# **RANCHO SANTIAGO COMMUNITY COLLEGE DISTRICT**

## **ADDENDUM NO. 2**

Bid #1422 Lots 2 and 7 Crosswalk Improvements Project  
at  
Santiago Canyon College

### ADDENDUM 2

DATE ISSUED: 2022.04.14  
 PROJECT NO: 2021-40118  
 DSA APPLICATION NO: 04-120877  
 SCALE: As indicated  
 SHEET NUMBER: **L5.101**

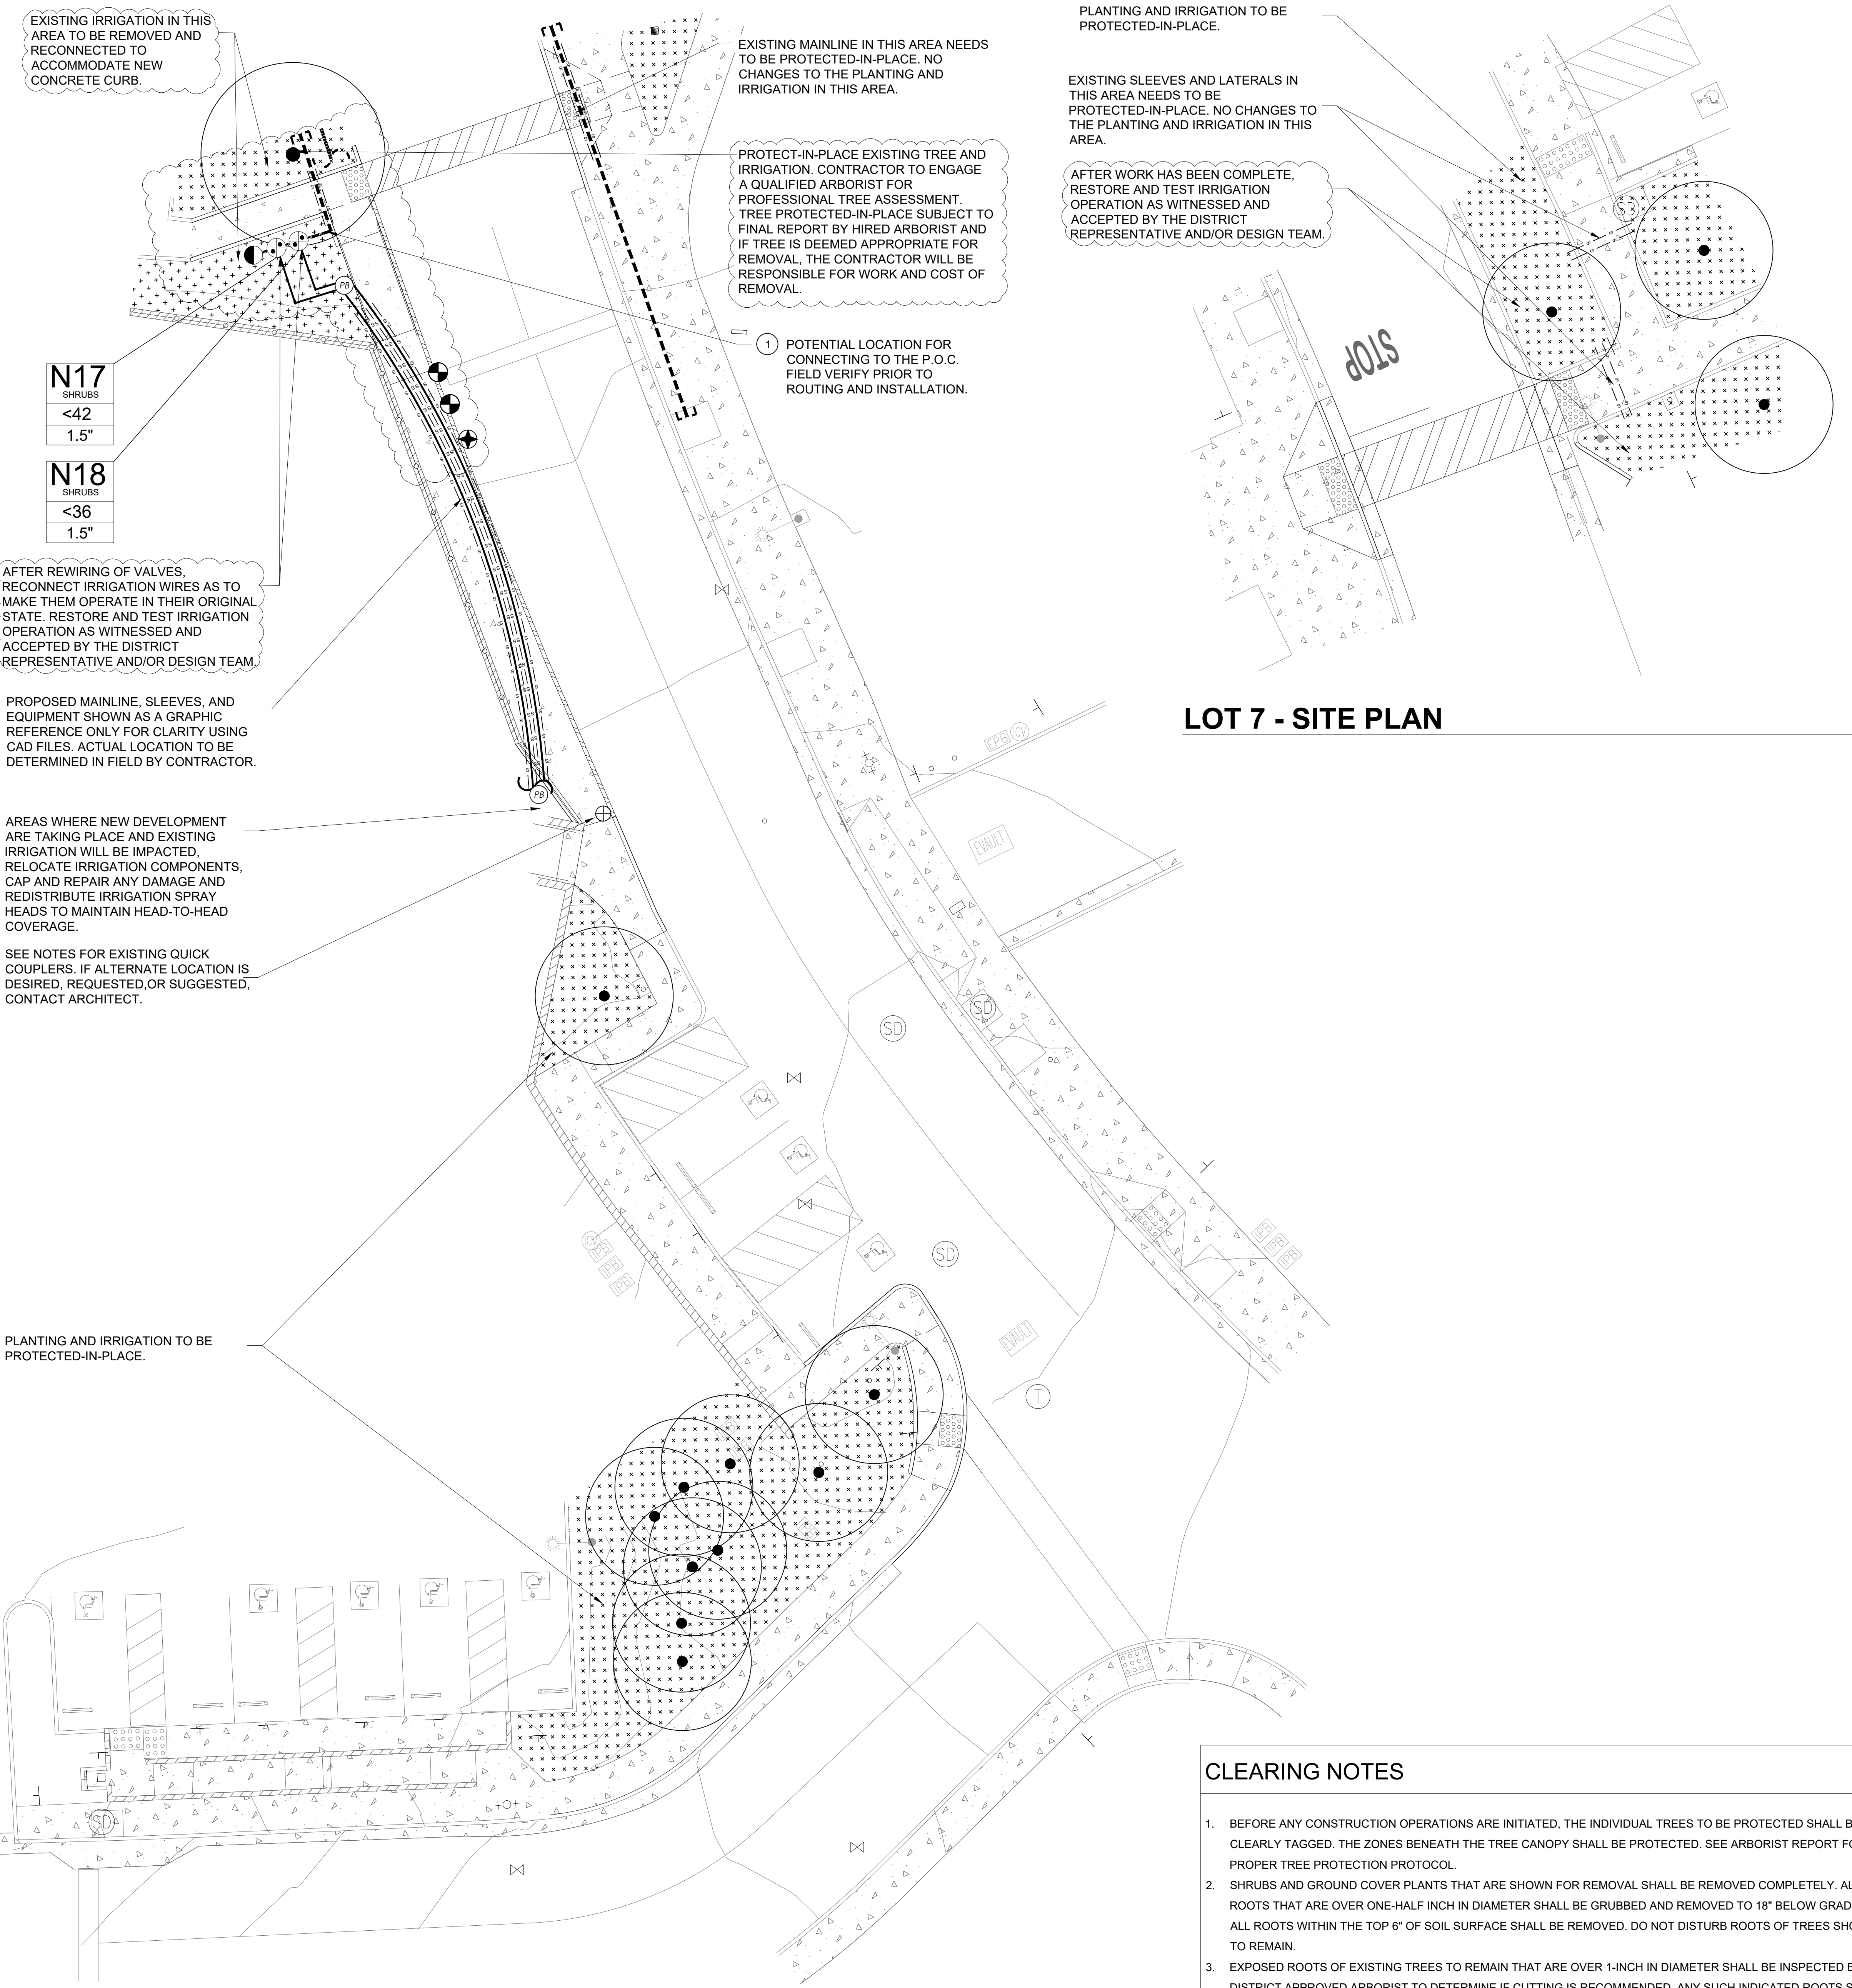
- A. Added note – “Protect-in-place existing tree and irrigation, and contractor to engage a qualified arborist for professional tree assessment. Tree protected-in-place subject to final report by hired Arborist and if tree is deemed appropriate for removal, the contractor will be responsible for tree work and cost.” Refer to ‘Lot 2 – Site Plan’ on sheet **L5.101**.

- B. Added note – “Existing irrigation in this area to be removed and reconnected to accommodate new concrete curb.” Refer to ‘Lot 2 – Site Plan’ on sheet **L5.101**.

- C. Added symbols depicting new locations for two (2) relocated valves and have been located northwest of its existing location. Refer to ‘Lot 2 – Site Plan’ on sheet **L5.101**.

- D. Added note – “After rewiring of valves, reconnect irrigation wires as to make them operate in their original state. Restore and test irrigation operation as witnessed and accepted by the District Representative and/or design team.” Refer to ‘Lot 2 – Site Plan’ on sheet **L5.101**.

- E. Added note – “After work has been completed, restore and test irrigation operation as witnessed and accepted by the District Representative and/or design team.” Refer to ‘Lot 7 – Site Plan’ on sheet **L5.101**.
- F. Updated Irrigation Utilities and Irrigation Piping legends. Refer to revised ‘Irrigation Utilities’ and ‘Irrigation Piping’ legends on sheet **L5.101**.
- G. For specific tree protection procedures, excavation, and construction requirements, refer to revised ‘**Detail D – Tree Protection**’ on sheet **L5.401**.

EXISTING IRRIGATION IN THIS AREA TO BE REMOVED AND RECONNECTED TO ACCOMMODATE NEW CONCRETE CURB.

PROTECT-IN-PLACE EXISTING TREE AND IRRIGATION. CONTRACTOR TO ENGAGE A QUALIFIED ARBORIST FOR PROFESSIONAL TREE ASSESSMENT. TREE PROTECTED-IN-PLACE SUBJECT TO FINAL REPORT BY HIRED ARBORIST AND IF TREE IS DEEMED APPROPRIATE FOR REMOVAL, THE CONTRACTOR WILL BE RESPONSIBLE FOR WORK AND COST OF REMOVAL.

AFTER WORK HAS BEEN COMPLETE, RESTORE AND TEST IRRIGATION OPERATION AS WITNESSED AND ACCEPTED BY THE DISTRICT REPRESENTATIVE AND/OR DESIGN TEAM.

AFTER REWIRING OF VALVES, RECONNECT IRRIGATION WIRES AS TO MAKE THEM OPERATE IN THEIR ORIGINAL STATE. RESTORE AND TEST IRRIGATION OPERATION AS WITNESSED AND ACCEPTED BY THE DISTRICT REPRESENTATIVE AND/OR DESIGN TEAM.
